# TOWN OF NEWBURGH PLANNING BOARD TECHNICAL REVIEW COMMENTS

PROJECT NAME: POPPY LANE AMENDED SUBDIVISION

PROJECT NO.: 21-26

SECTION 6, BLOCK 1, LOTS 113, 114, AND 115, OFF OF LESTER CLARK ROAD LOTS 2, 3 & 4 OF THE MARTUSCELLO SUBDIVISION, FILED MAP #8866 5/18/1988 RESPONSE TO COMMENTS

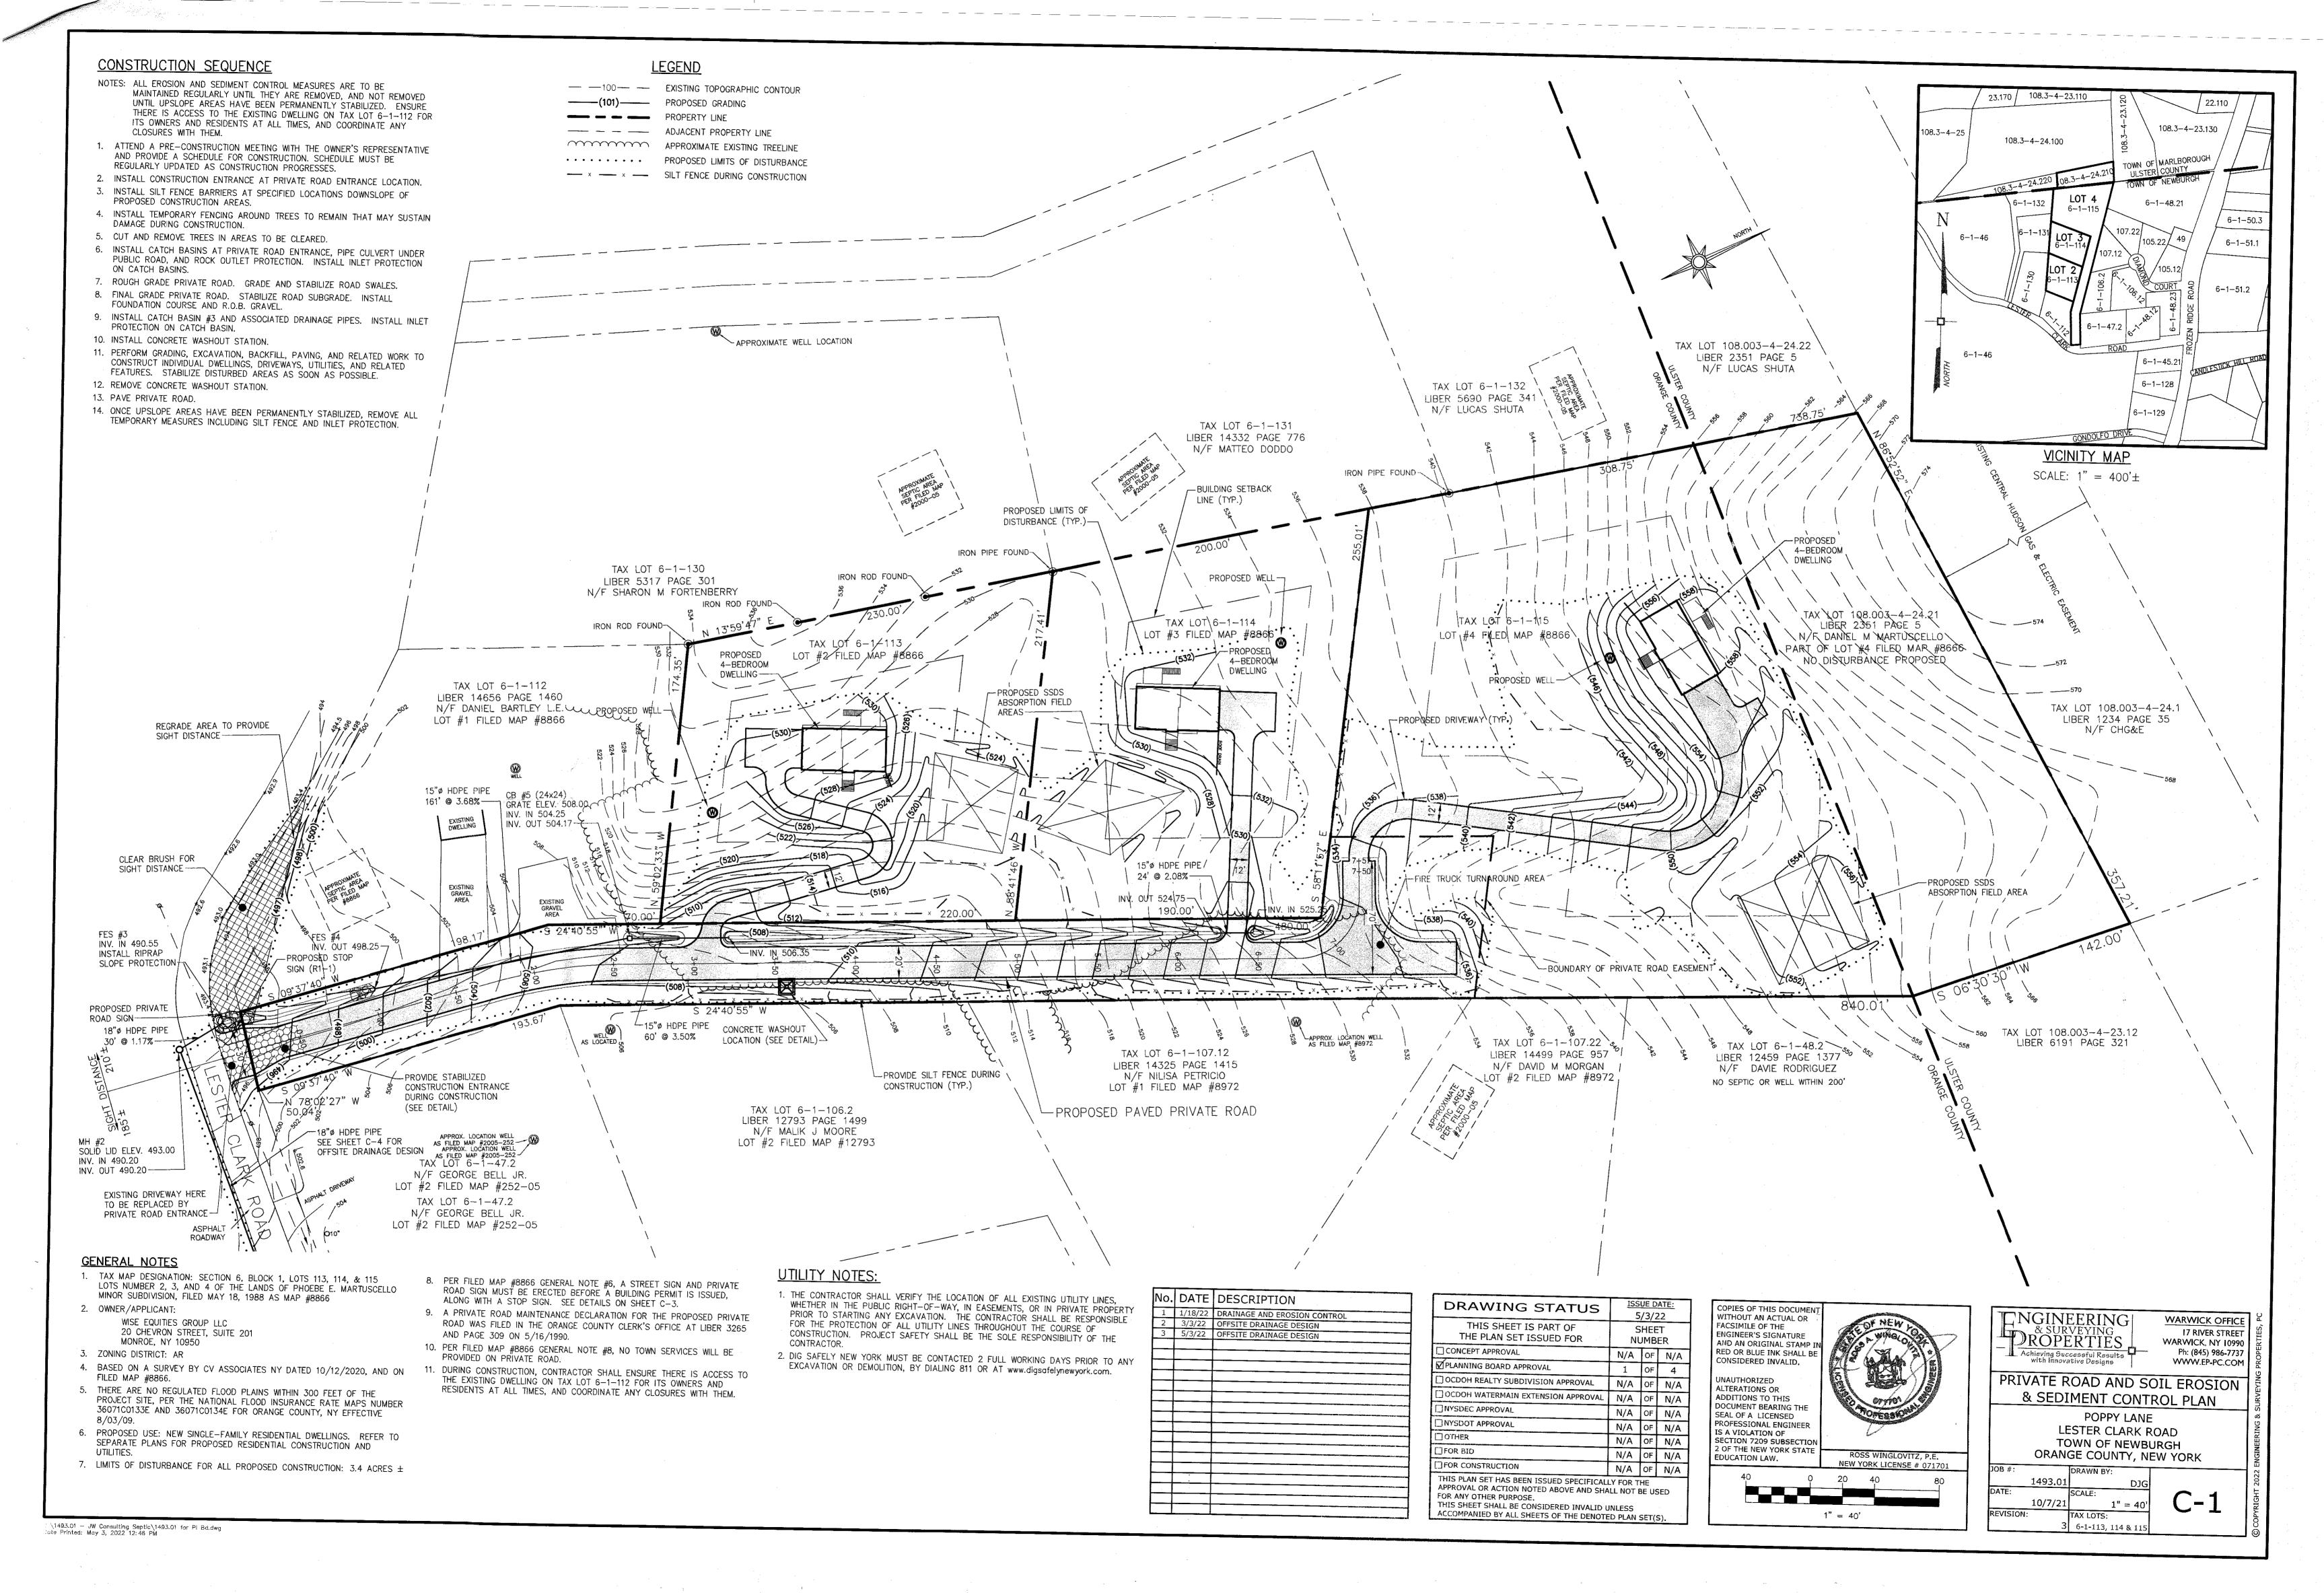
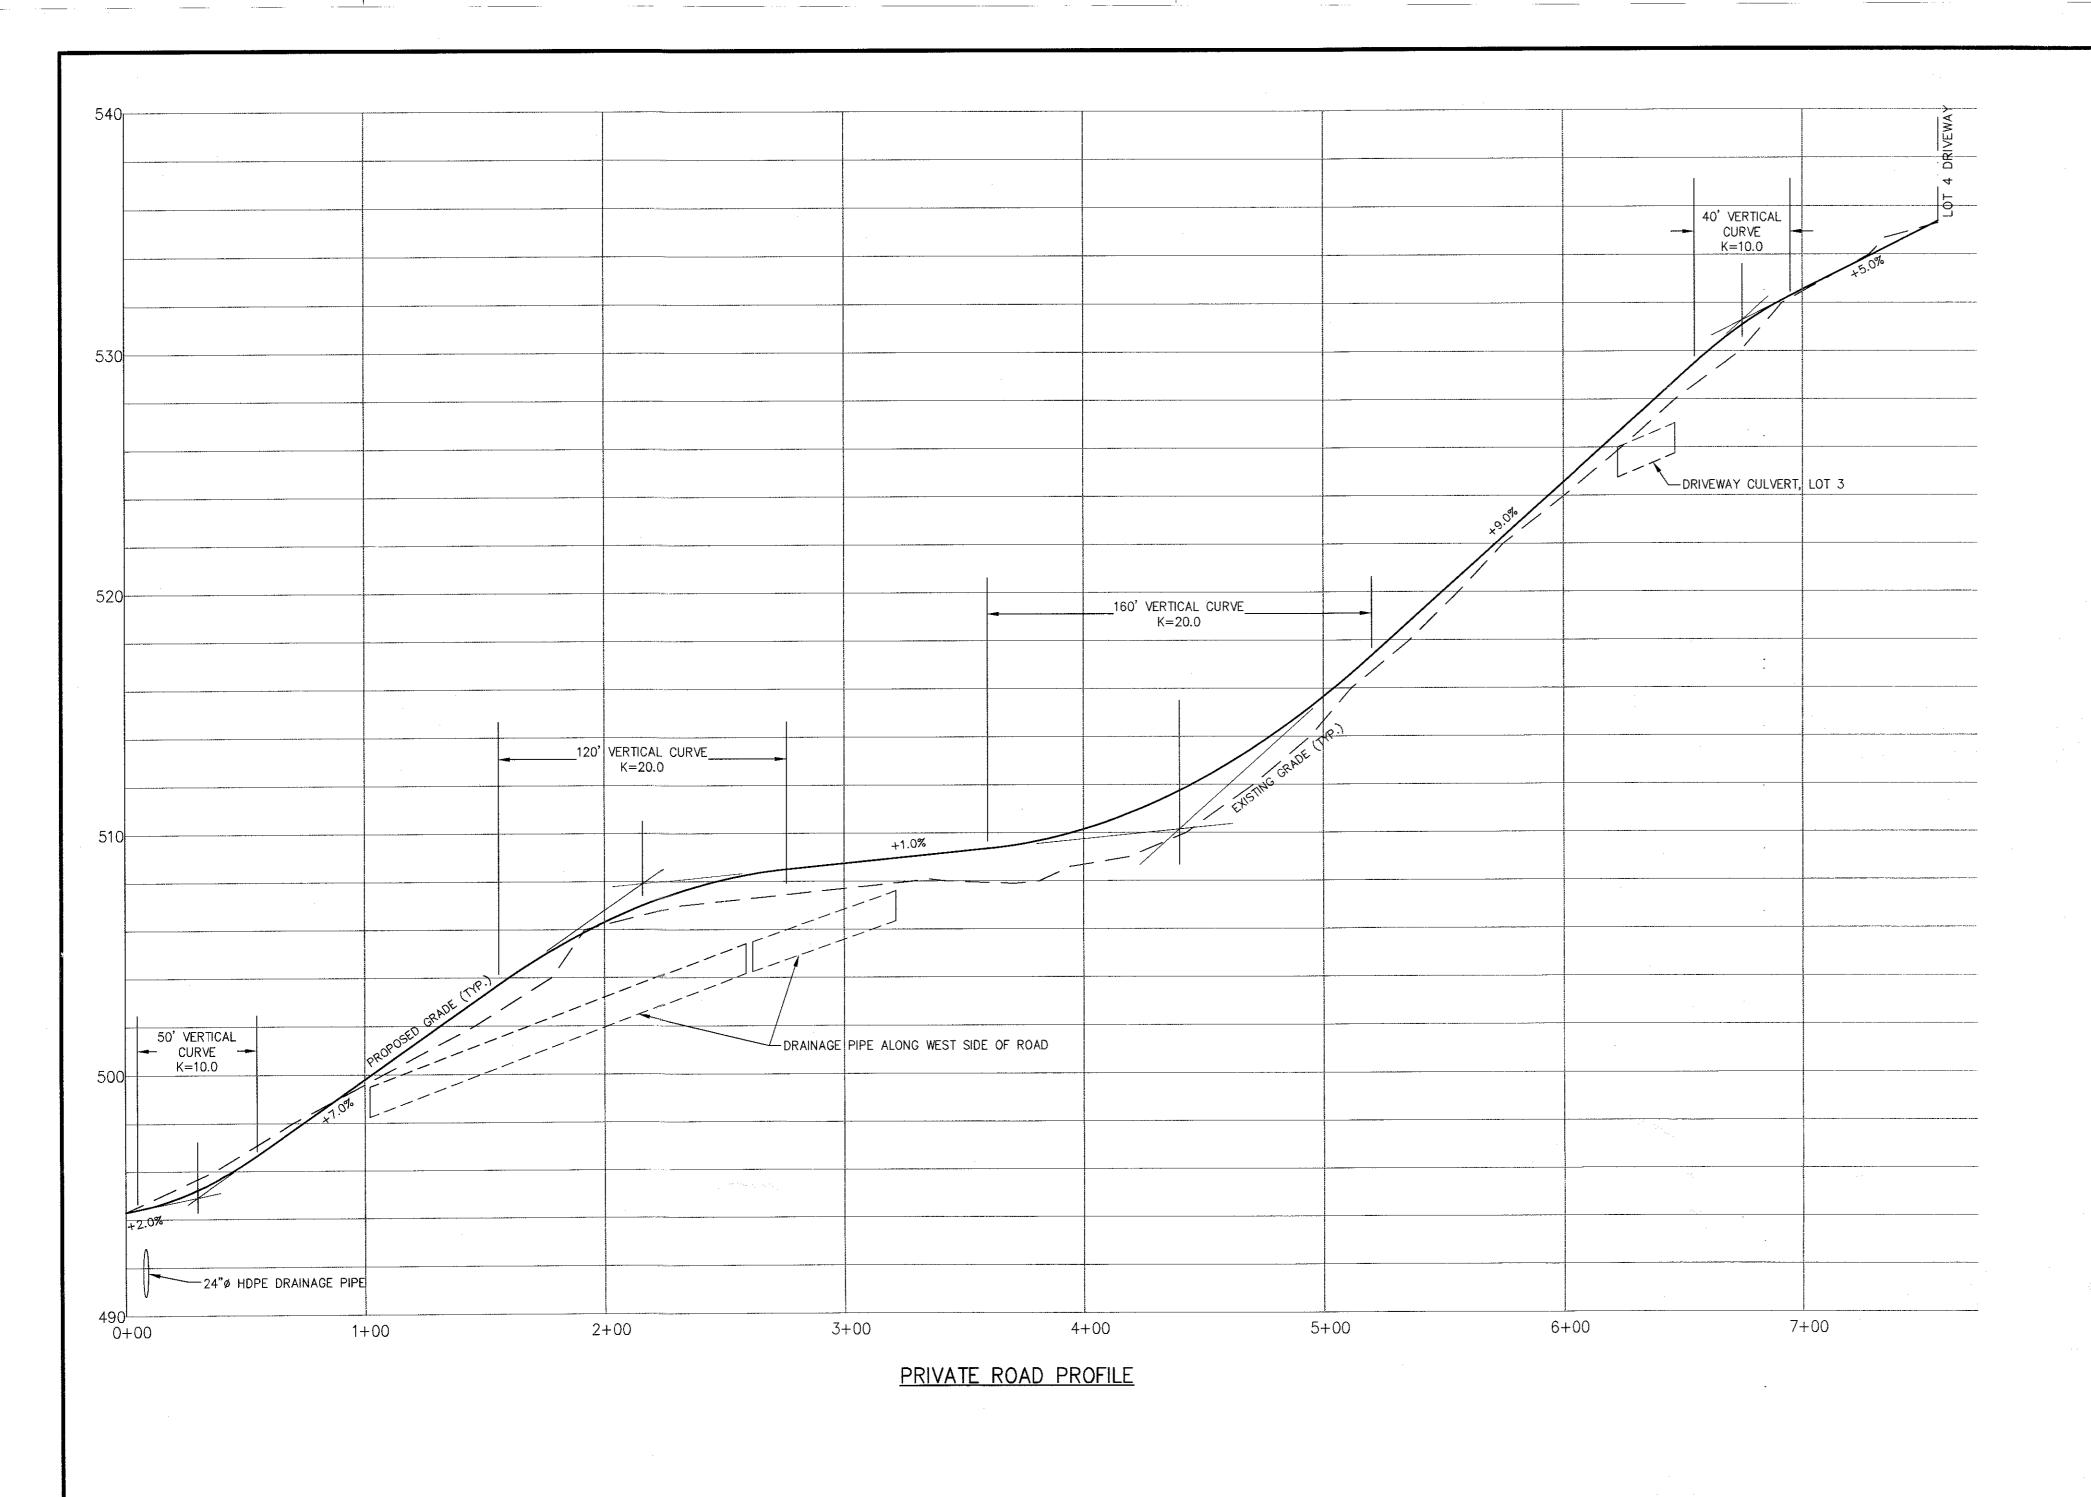
- 1. The project is before the Board for a continuation of a Public Hearing. Previously unresolved drainage issues are being addressed.
- 2. The applicant's representative have provided a Stormwater Design which will convey stormwater from the private road entrance to Lester Clark Drive in an easterly direction to an existing closed pipe drainage system. The existing drainage system appears consist of 18" diameter pipe discharging to a 15" diameter pipe. The addition of the pipe from the site to the existing catch basin will add an additional 18" pipe to the system. The capacity of the existing 15" pipe should be evaluated to ensure that tributary flow can be conveyed for the design storm event.

- 3. The discharge location of the existing 15" HDPE pipe should be depicted on the plans. This is required to identify any downgradient impacts of the increased runoff tributary to the 15" stormwater system.

- No response required at this time.
- 2. The section of Lester Clark Road where the off-site drainage is to be provided has been surveyed, and the design of the off-site drainage has been revised. This information is on Sheet C-4 of the revised plans.
- 3. The revised plan includes two manholes, MH#1 and MH#2, along the south side of Lester Clark Road.
- 4. A preliminary discussion with the highway superintendent indicated that the concept was acceptable. Plans have been sent to his office for review.
- 5. The existing culvert has been surveyed; it is an 18" diameter culvert with catch basins at both ends. Instead of using this culvert, a new culvert across Lester Clark is proposed at the location of the new private road entrance.
